Ref: NA29S.314232 County Dublin, County Meath, County Kildare

Re: DART+ West Railway Order - Dublin City to Maynooth and M3 Parkway

We write to you in relation to the abovementioned Railway Order Application for the development of a dart depot behind our home at Doondara House, Branganstown, Kilcock, Co. Kildare W23P7KF. We recognise the importance of the Dart+ West project to the public transport network, however the current plan would considerably alter the environs of our home to the detriment of our residential amenity. The construction of an industrial site of this nature would completely alter the landscape. This is acknowledged in *EIAR Volume 2 Chapter 15 Landscape and Visual Amenity* at Page 45 which refers to landscape and visual effects on those properties located adjacent the works, which are not included within land acquisition. The fact that Dart+ West would not serve the rapidly expanding town of Kilcock means that we would have all of the inconveniences of having an industrial site on our doorstep without the benefit of additional public transport options it could offer.

For reference our property is the circled property above, directly bordering the Depot site.

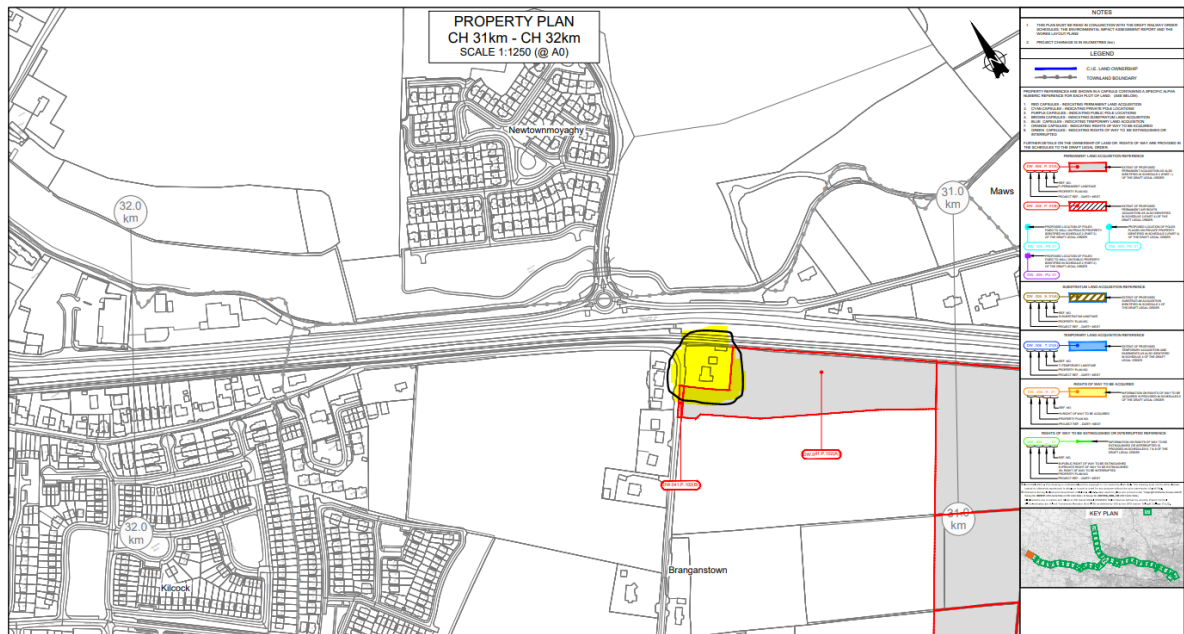
4. A number of options were put forward by Irish Rail for consideration at consultation phase. None of those options showed SEB/PSP buildings within the vicinity of our home. Indeed, it appears that this was not considered during the Environmental Impact Assessment phase as neither building is shown at the bottom left hand corner of figure 4-240 below (EIAR Volume 2 Chapter 4 - SEB and PSP buildings). We note that SEB buildings require an external lighting system with motion control, that the PSP building will comply with existing standards for electrical installations (IS: 10101:2020), there will be a diesel generator inside the PSP buildings to provide power in case of power failure and that during normal operation, it will not be a source of noise or emissions. We submit that there is no need for electrical installations of this nature to be located in close proximity to our home on such a large site and we have concerns in respect of the safety aspects of such buildings at the proposed location.

There are seven main facilities shown Figure 4-240 below.

5. Having a young family so close to a site of this nature is hugely concerning to us as parents. While we expect the site would be secured, we believe fencing is insufficient to ensure all boundaries remain intact at all times and inaccessible by children. Sites of this nature can also attract anti-social behaviour. We suggest construction of a boundary wall to the south and east of our property running up to the emergency entrance, preferably in the early stages of site development if the railway order application is approved. We would also require adequate space to be left between our hedge and the wall so that we have continued access for hedge maintenance purposes. Responsibility for maintenance and monitoring the perimeter should rest with Irish Rail.

6. The EIAR states that *“the road layout for the depot has been designed to allow HGVs around the site. Consideration has been given to special HGVs required to transport rolling stock around the depot. Road access will be provided to all facilities for servicing and maintenance. Page 4/189”*. It is proposed that an emergency access road would exit the site directly south of our property onto what is a local secondary road L5042. Much of the road cannot accommodate two-way traffic at present. A “give way” system is in operation at the moment where the road narrows from two lanes to one around a 90-degree bend just outside of our property (see photo below. This has already been the scene of a road traffic accident. The junction is in need of an upgrade and is completely unsuitable for the purpose of an emergency access route. Should an emergency actually occur, that road is not suited to servicing the site for any increased volume of traffic, particularly HGV. We object to the location of the emergency exit route so close to our property given the vast amount of space available on the site and the current problems with road layout.

7. Ours would be the only property bordering the western perimeter of the depot. It is proposed that the depot would operate 24 hours a day throughout the year, yet the EIAR makes no

reference to the potential impact of noise or vibration at the location of our home. We are particularly concerned by the noise levels which would arise from the location of the proposed rail access to the depot, the test track and the emergency access road. We are also concerned about the noise during the construction phase of the project, particularly breaking of ground, piling and excavation. We ask that restrictions are placed on the hours of construction in the immediate vicinity of our home.
